**Bulletin #11 of 2024. November 19, 2024**

## **CHANGE TO PRODUCT BULLETIN**

**P/N 540-552 Side Block Wrench Now Has New Features**

**Products Affected:** P/N 540-552 Side Block Wrench

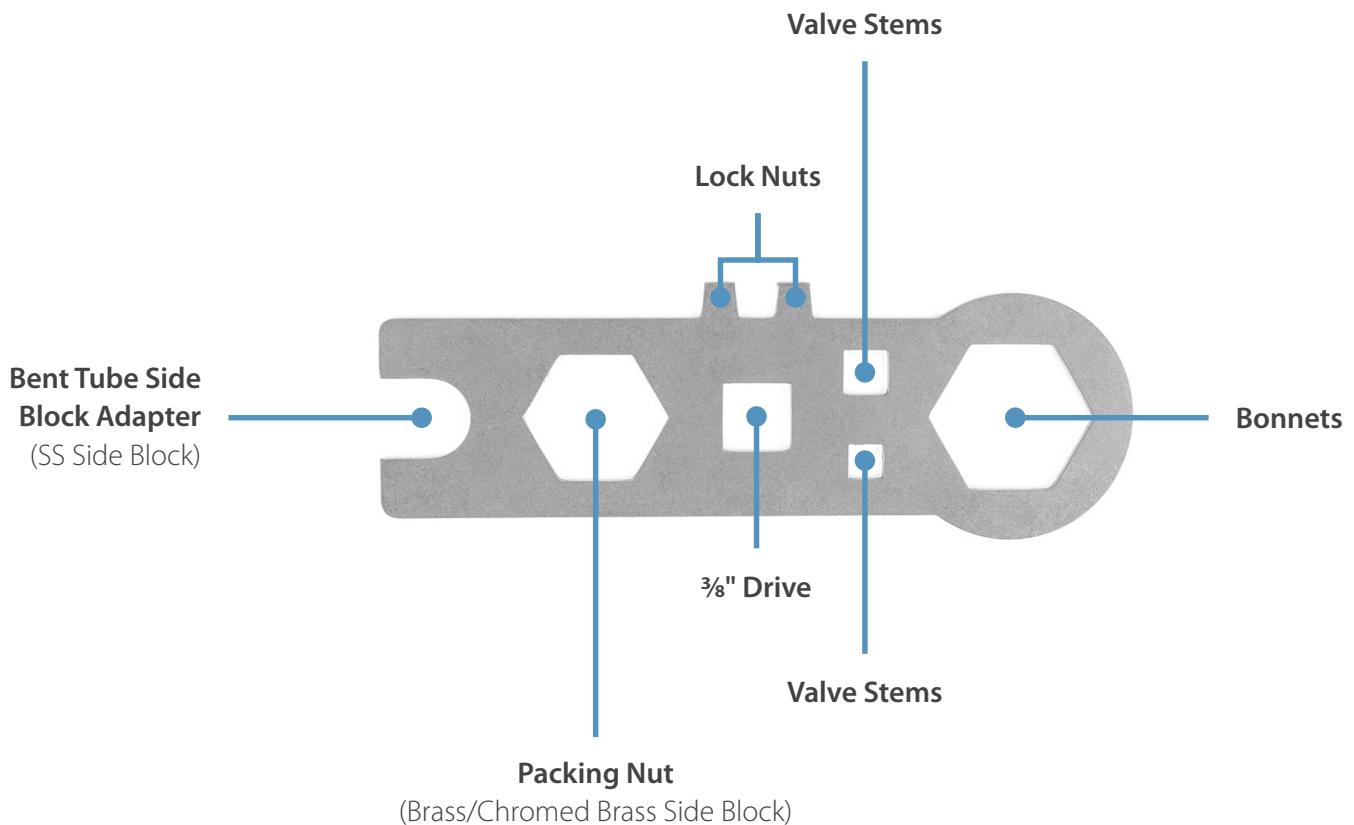
The P/N 540-552 Side Block Wrench has been modified with additional square holes that fit each of the squares at the top of the Steady Flow and EGS valve stems. It also features two hexagon openings for both Steady Flow and EGS bonnets, "Screwdriver Teeth" for installing the Steady Flow & EGS Knobs, and a center square to attach a  $\frac{3}{8}$ " driver. This allows it to be used with a torque wrench for the Bent Tube Side Block Adapter.
